**MEETING NOTICE – SITE REVIEW COMMITTEE**

**RE:** 3794 Packerland Dr., HB-950 & HB-950-4; New 55,000 sf Warehouse Addition and Associated Site Improvements

**FROM:** Todd Gerbers, Director of Planning and Code Compliance

**ISSUE:** Discussion and action on request for a 55,000 sf., warehouse addition and associated site improvements

POND PLAN

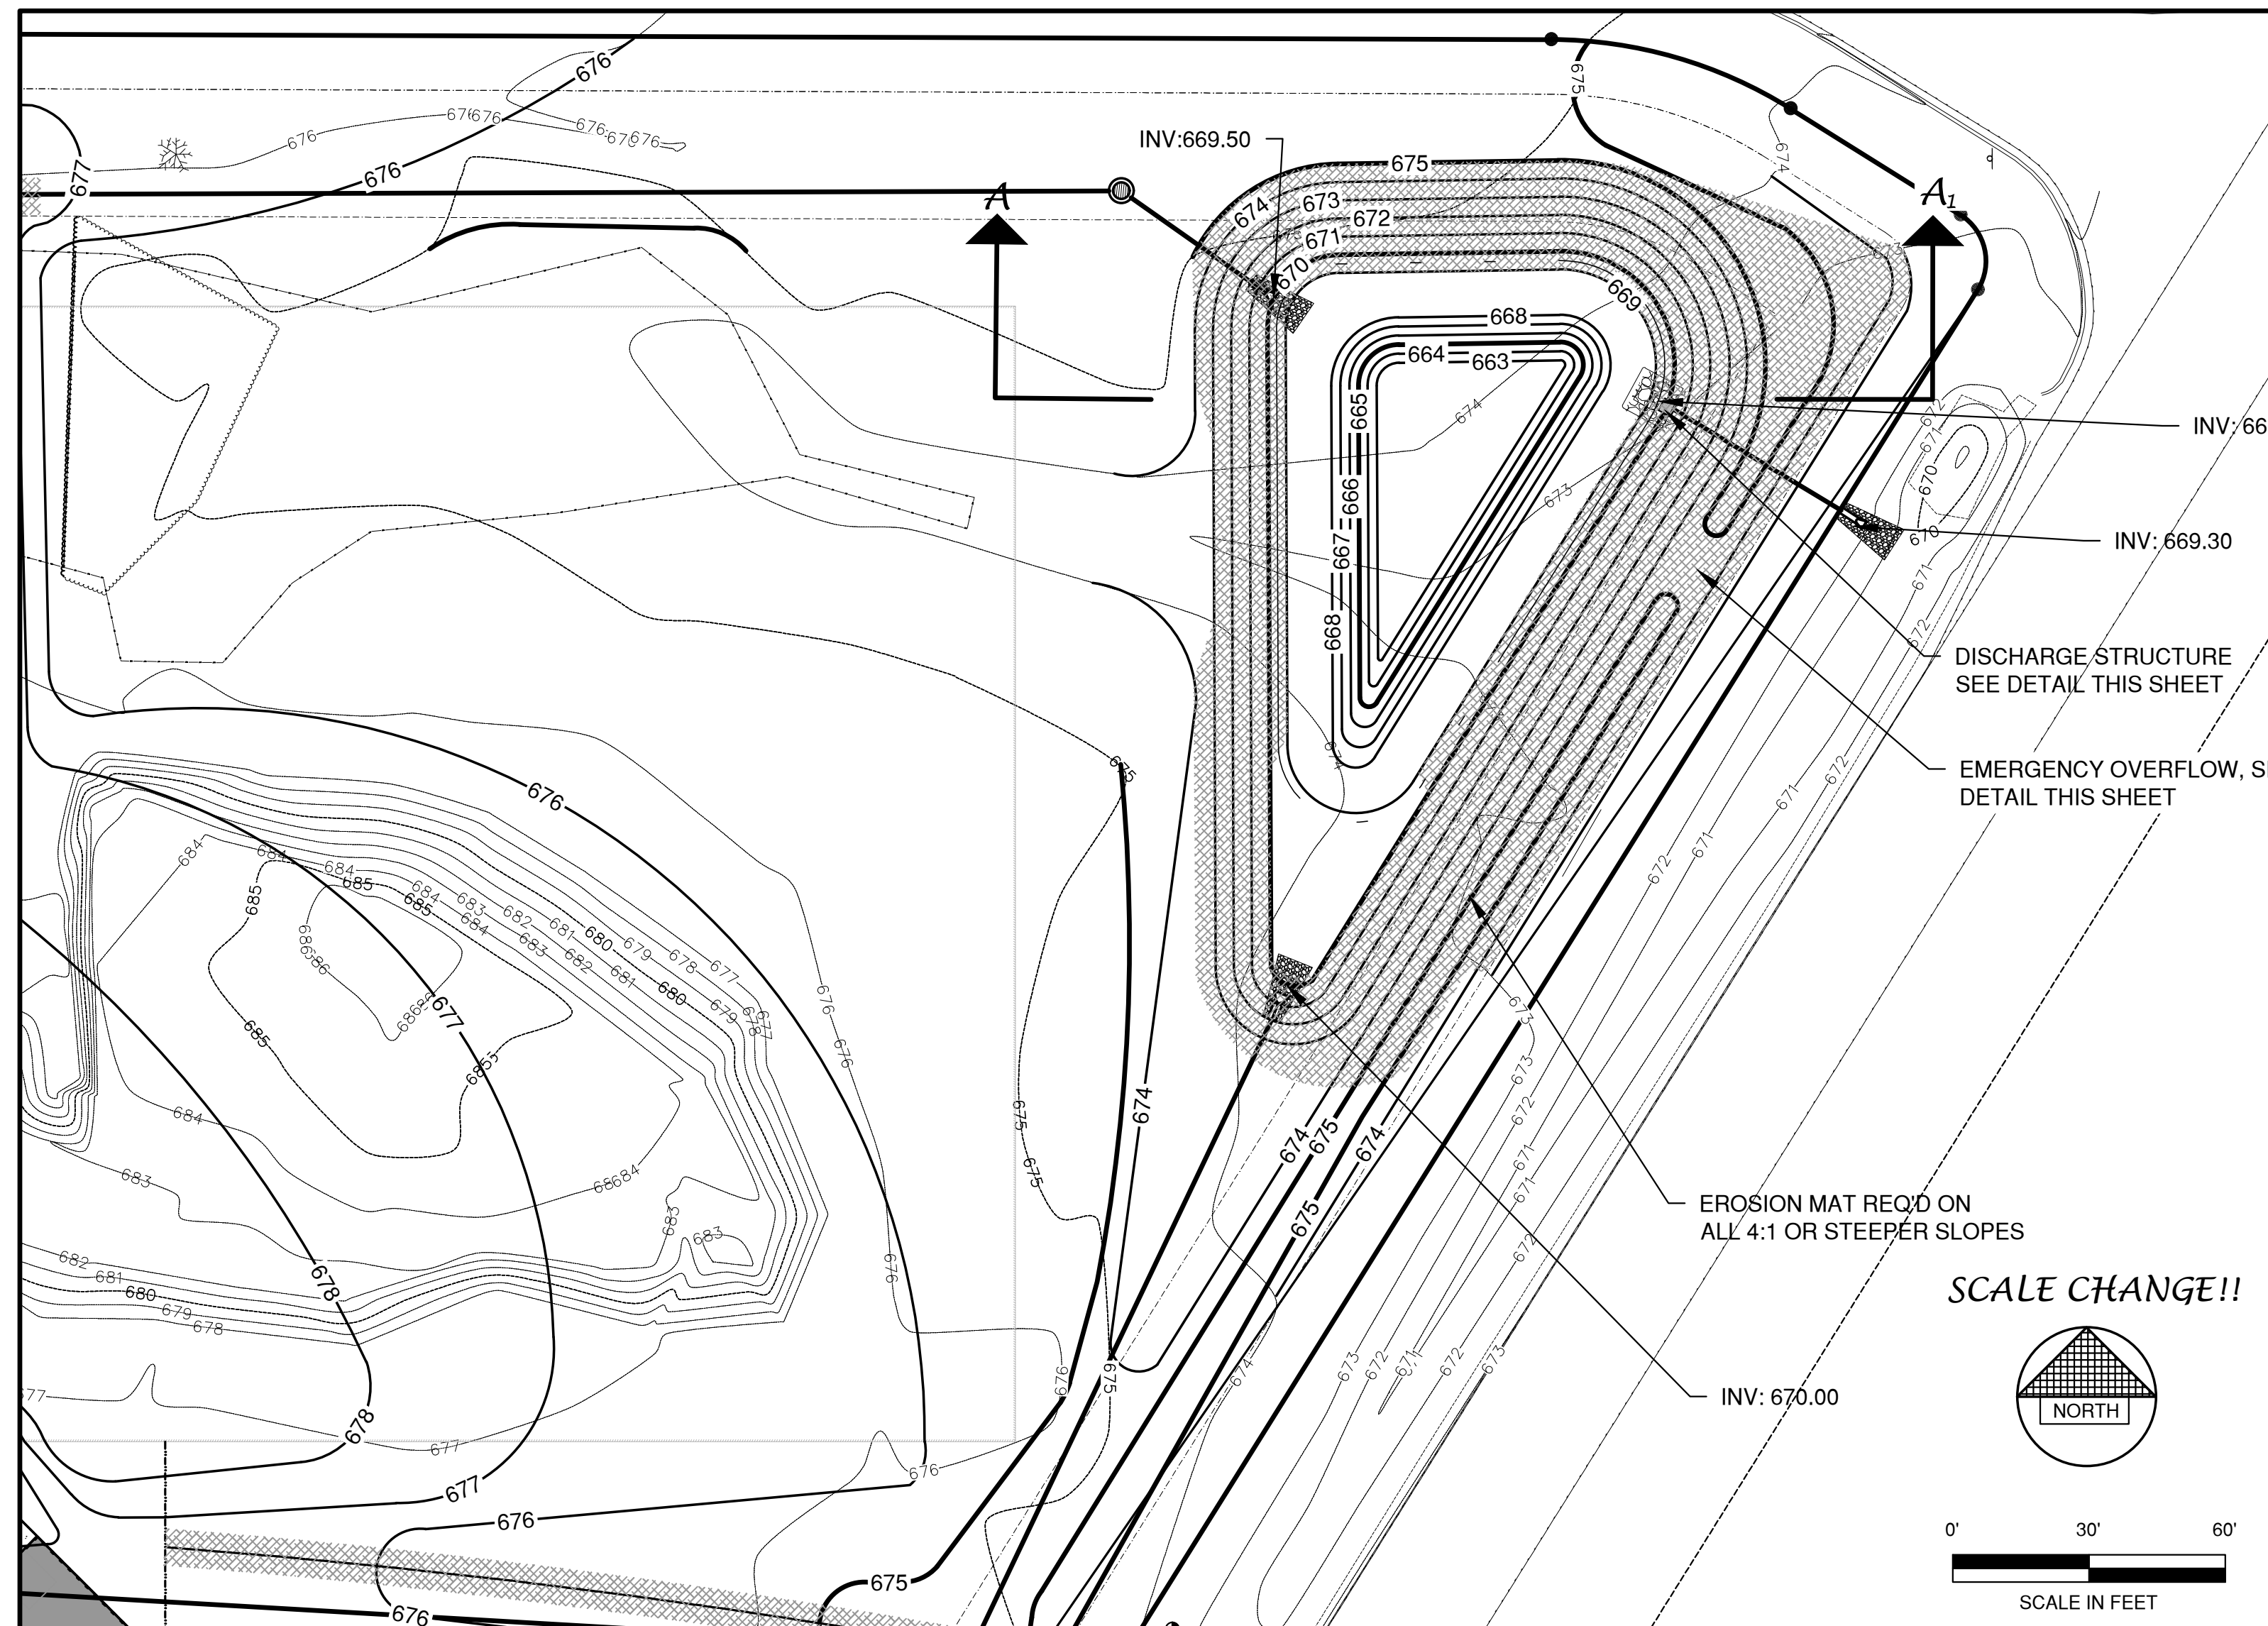
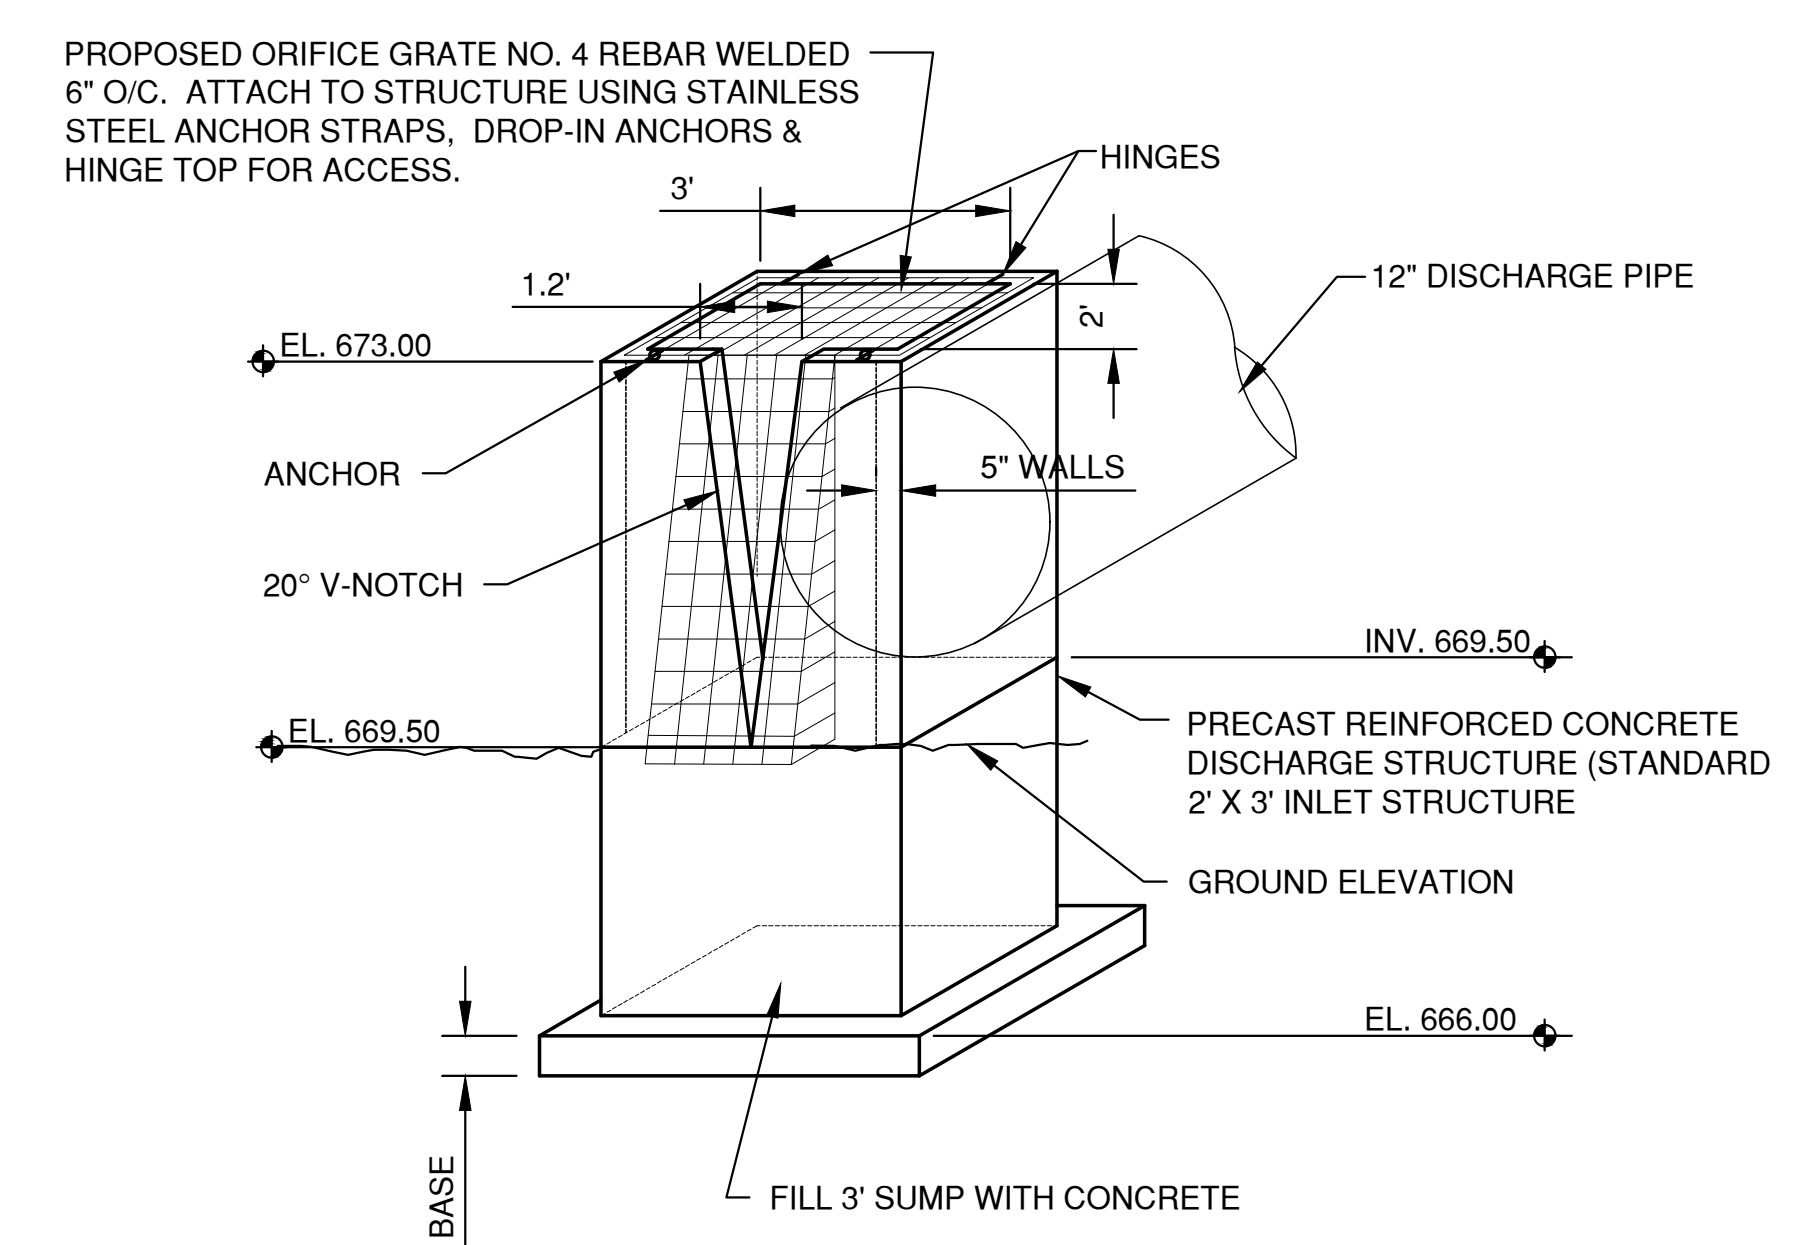
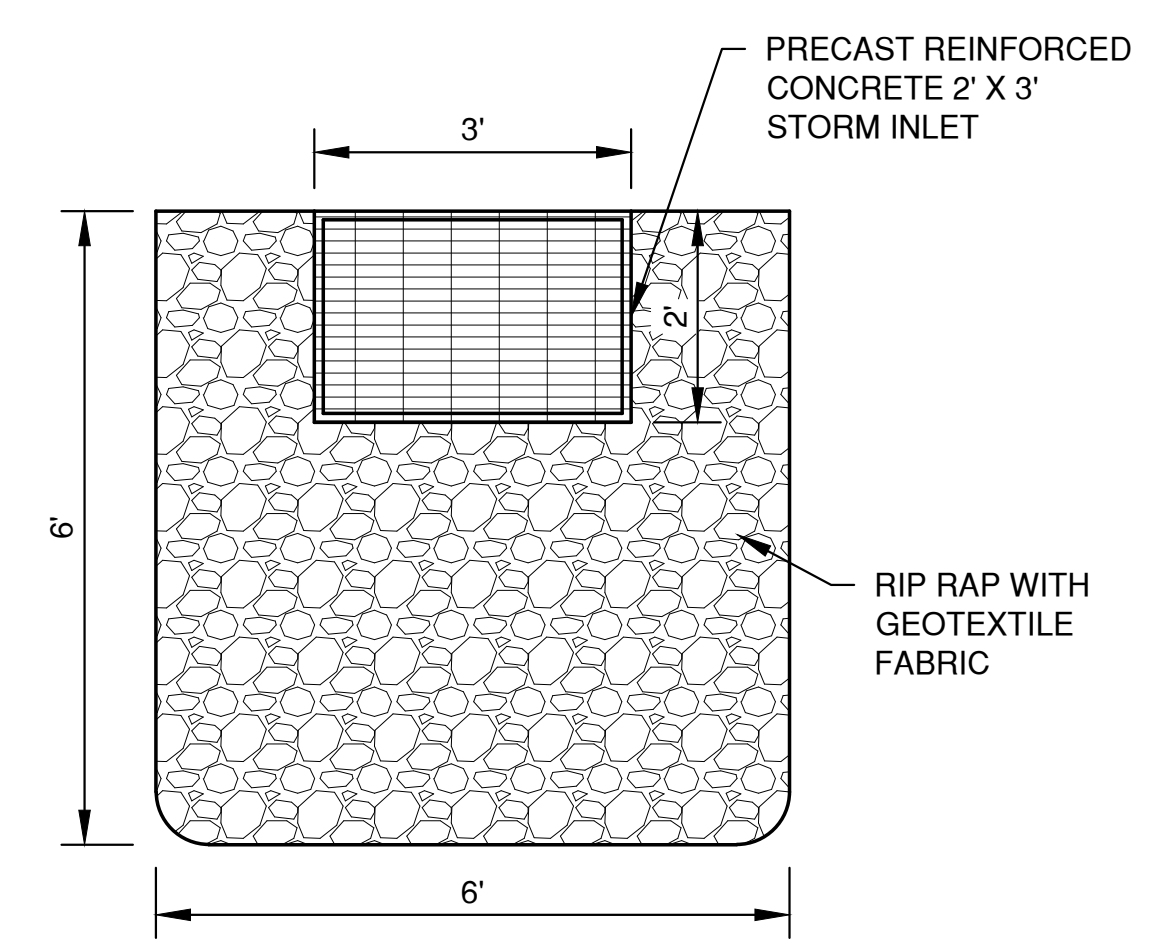
6. Submit a more detailed landscape plan to Staff for approval of the landscape areas around the street sides of the new wet detention pond to make it more of a landscape feature due to its close proximity to the public roadways.;
